Design Compliance Report

Proposed Use of Existing Buildings as Tea House

18 Myoora Road, Terry Hills NSW

Report Number & Revision:	MSA0496_D_REV01
Prepared For:	Vardman Holdings
Date of Issue:	09.12.2019

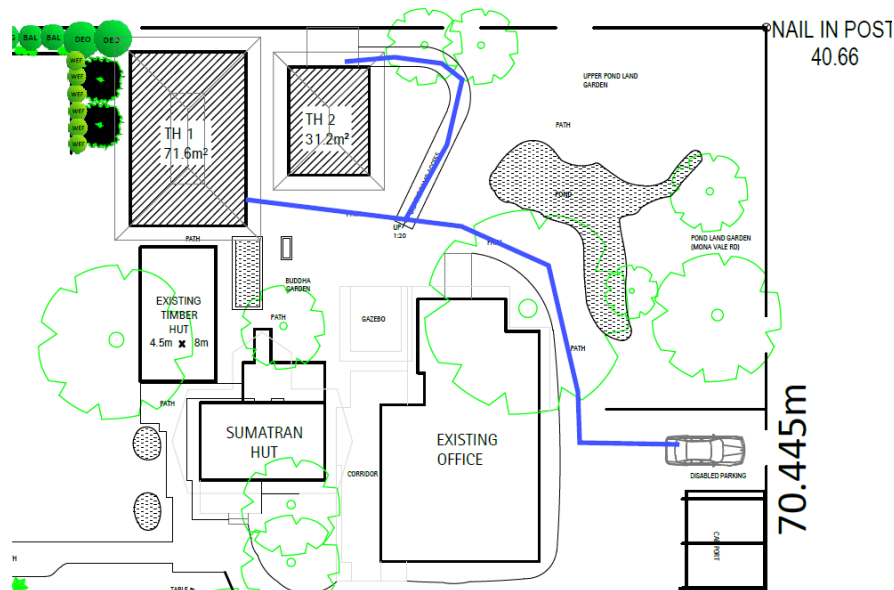
The subject buildings structures are shown in red in the extract from the master plan below.

This report is based on the assumption that there is no designated pedestrian entrance to the site (i.e. all staff visitors will arrive by vehicle and park in designated carparks. The designated carparking area for the subject buildings/structures is understood to be located at the far end (Mona Vale Road end) of the site.

An accessible path of travel from the carparking area to the subject buildings must be provided (see assumed path in blue below). The current surface of this path is gravel, which may require further compaction or other treatment so as to provide a sufficient accessway for wheelchair users.

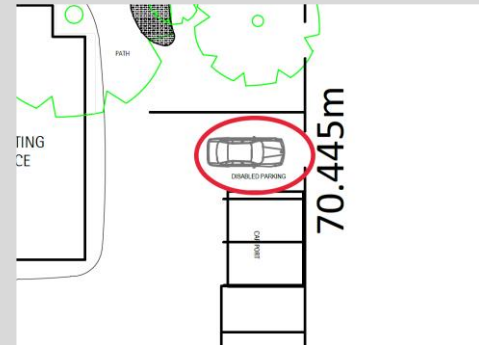
<p>D3.3</p> <p>Parts of building to be accessible</p>	<ul style="list-style-type: none"> Ramps (other than fire isolated ramps) must comply with Clause 10 of AS1428.1-2009. Stairways (other than the fire isolated stairways) are required to comply with Clause 11 of AS1428.1-2009. 	<p>See comments in BCA D3.1 above.</p>
